**CITY OF VANCOUVER  
DEVELOPMENT SERVICES, BUILDINGS &  
LICENSING**

**DEVELOPMENT PERMIT STAFF COMMITTEE  
MEETING  
October 3, 2018**

**688 West 41<sup>st</sup> Avenue (Complete Application)  
DP-2018-00633 – CD-1 (1)**

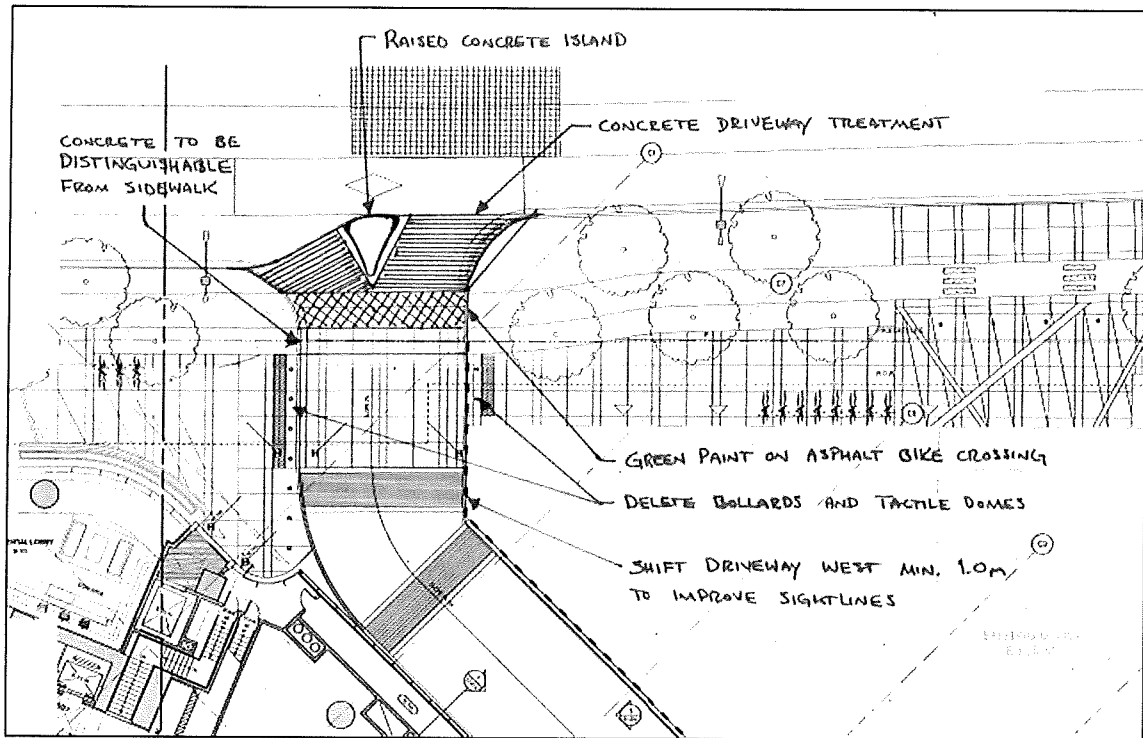
- A.2.26 provision of the second row of trees on the West 41<sup>st</sup> Avenue frontage completely on private property;

**Note to Applicant:** Relocate the first 3 trees east of Manson Street parkade entrance proposed for the second row onto private property (refer to drawing L2.0).
